株式会社ハギテック

ミニフィッティングの形状変更について

対象型式：244-2241-75(VFT506)

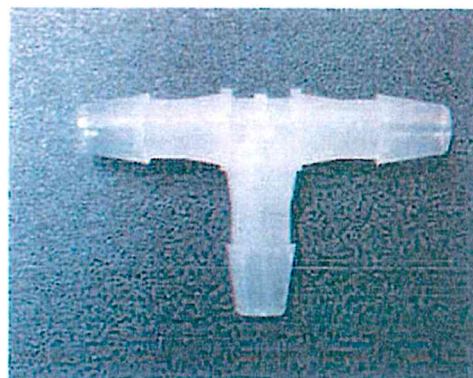
同系統の商品で本品のみ形状変更になります。新形状品の詳細は下記イメージならび別紙図面(2/2)にてご確認ください。中央のブロック形状がなくなり、チューブ接続タケノコの外径が少し太くなりました。

旧形状品

新形状品

また形状変更前の製品におきましては弊社在庫がなく、現在は新形状品のみの供給となります。何卒、ご理解ならびご容赦賜りますようお願い申し上げます。
